Interactive comment on “Simplified representation of runoff attenuation features within analysis of the hydrological performance of a natural flood management scheme” by Peter Metcalfe et al.

Received and published: 9 October 2017

Fig. 1. Eden headwaters to Great Musgrave Bridge (223km²), showing context within Cumbria, UK, rain gauges and gauging stations, and hillslope storage sites identified through JFLOW screening.

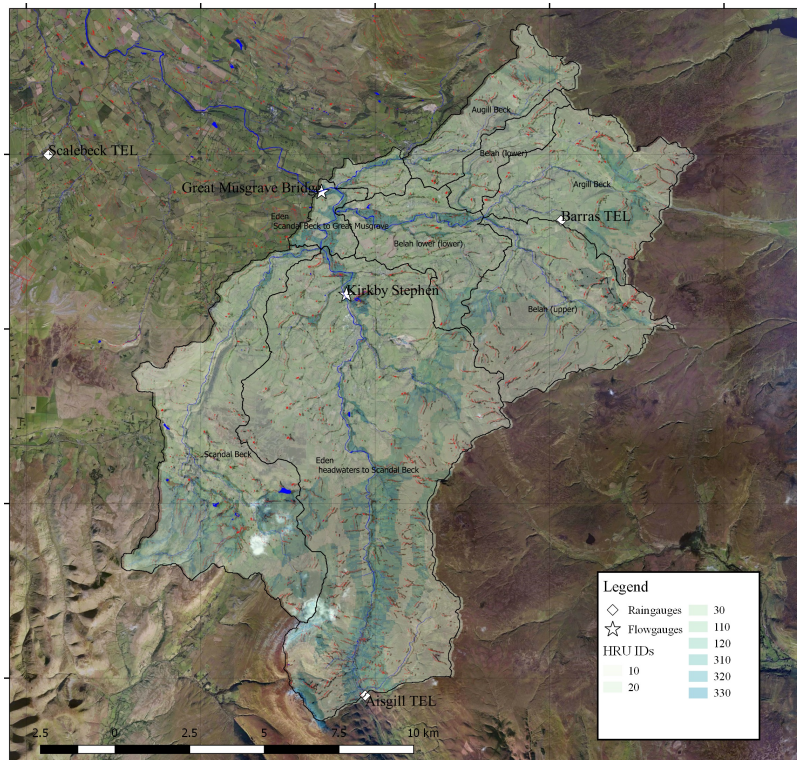
p. 12 I don't understand how 8 HRU units correspond to the JFLOW simulation. Was JFLOW used on 8 separate subregions? Or are the HRUs related to the TOPMODEL simulation? Please, clarify. What is approximate size of the HRUs (are they similar in size)? Can you include HRUs boundaries on Fig. 3?

Fig. 3: I suggest to include the HRUs boundaries. Position of the NFMs would be also interesting, but there are maybe too many of them.

The spatial extent of the "RAF" HRU corresponds to the accumulation areas identified by the JFLOW simulation. Those of the others is determined by the Topographic Wetness Index (TWI, see later comment) as for TOPMODEL. The HRU boundaries can be included on the diagram as requested. The figure will be revised to show HRU boundaries and their areas given. The areas range from 2 to 101 km².

As for Comment 4. It may be that putting both the HRU boundaries and the RAF positions is confusing. Our inclination would be to show only the RAFs. We include a revised figure (Figure 1) with these boundaries included.

Fig. 2. Simulated discharges at Great Musgrave Bridge across the calibration period described in the main text for behavioural realisations alongside rated observed discharges.

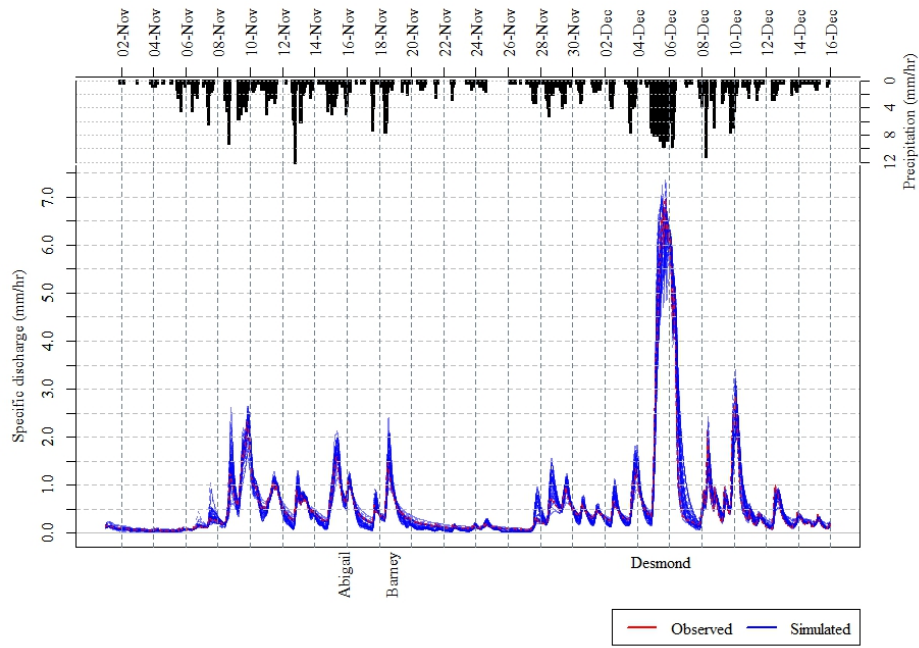
Fig. 4: Why are there more red lines? I would think that there is only one observation

in the single gauge.

The Precipitation bars are too thick. In the given scale the daily precipitation amount on 13th Nov would be app 240 mm.

Thank you for pointing this out. The display of the observed values are indeed in error as the colours had been incorrectly applied; every other time series was being displayed in red. This has been fixed: see Figure 2.

This has been addressed: see Figures 2 and 4.

Fig. 3. GLUE "dotty" plots showing overall weighting (likelihood) scores for each of the 348 behavioural runoff simulations identified against the three model outputs described in the text.

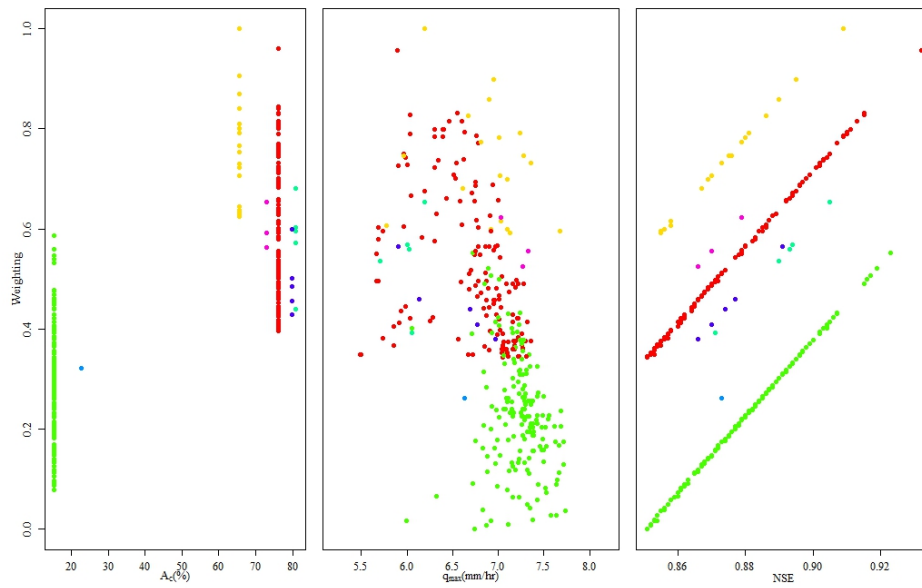
I don't understand to the description of the GLUE results (p.13, l. 13). Why the Ac around 65% gives the best NSE? It does not seem like that on Fig. 5.

p. 13, l. 10: 7 distinct values of A_c are mentioned in the text, only 3 are on Fig. 5.

Due to the problem with the colouring (see response to comment 19) the Ac with the best NSE wasn't identified: it is in fact 75%.

Unique colours were not being applied to the unique values. This has been rectified: see Figure 3.

Fig. 4. Surface excess storages across the lumped RAF unit with maximum storage set to 1m, applying each of the three mean residence time scenarios considered.

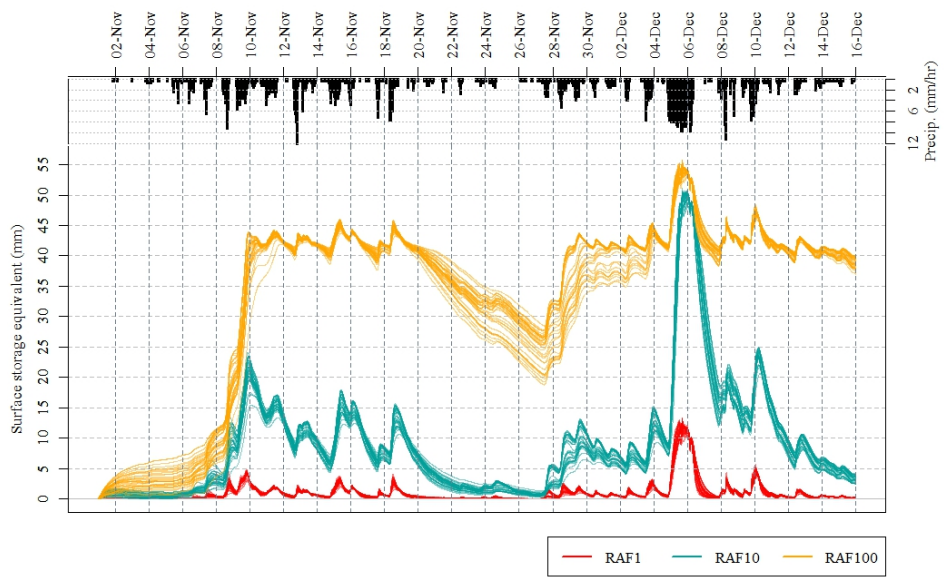
Fig. 5: What are the thin lines with max excess storage around 0.2 m, visible after Desmond storm? Why are they so different from most of the simulation results (for all the RAFs)?

These were the results of simulations that encountered numerical errors and should have not been included in the set identified as behavioural. We will try to pin down what is causing this anomalous behaviour. The corrected figure is included here as Figure 4.
